**HISTORIC AND DESIGN REVIEW
COMPLIANCE AND TECHNICAL ADVISORY BOARD
May 17, 2024**

HDRC CASE NO: 2024-182
ADDRESS: 328 MADISON ST
LEGAL DESCRIPTION: NCB 744 BLK 3 LOT 18
ZONING: RM-4, H
CITY COUNCIL DIST.: 1
DISTRICT: King William Historic District
APPLICANT: Steven P Moreno | SM-LANDSCAPES
OWNER: WELLS SCOTT R & MARY K
TYPE OF WORK: Steel planter boxes construction
APPLICATION RECEIVED: May 7, 2024
60-DAY REVIEW: July 6, 2024

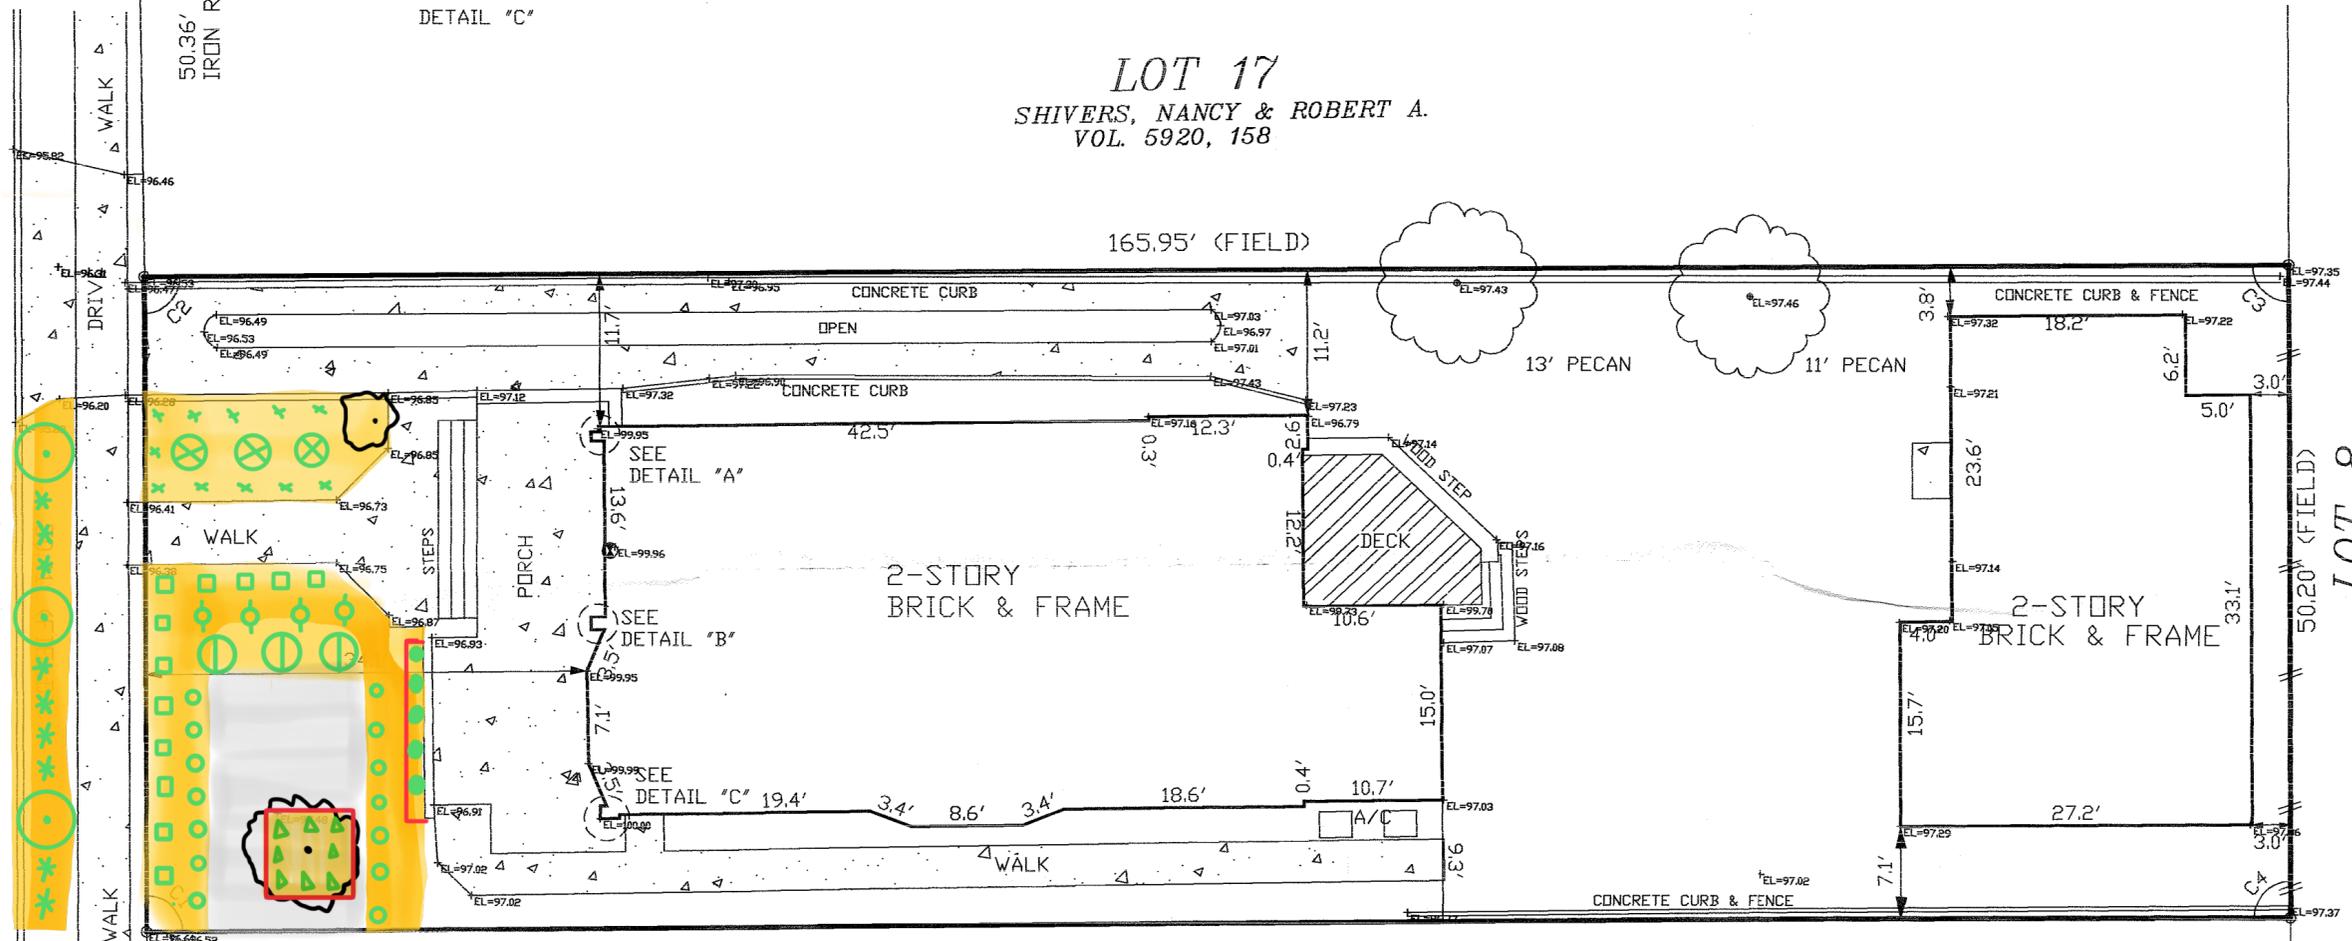
- c. PLANTER BOX CONSTRUCTION (FRONT FAÇADE) – The applicant is requesting approval to construct a steel planter box along the front façade of the primary structure to measure 18 inches in height. The Historic Design Guidelines for Site Elements 1.A.iii. states to minimize changes in topography resulting from new elements through appropriate siting and design. New site elements should work with, rather than change, character-defining topography when possible. The construction of the proposed steel planter box does not conform to Guidelines.

- d. PLANTER BOX CONSTRUCTION (FRONT TREE) – The applicant is requesting approval to construct a steel planter box surrounding the front yard tree to measure 18 inches in height and eight-by-eight feet in size. Site

Elements 1.A.iii. states to minimize changes in topography resulting from new elements through appropriate siting and design. New site elements should work with, rather than change, character-defining topography when possible. The construction of the proposed steel planter box does not conform to Guidelines.

Staff does not recommend approval of items 1 and 2, based on findings a through d. Staff recommends the applicant pursue a low-profile landscape edging for the desired design.
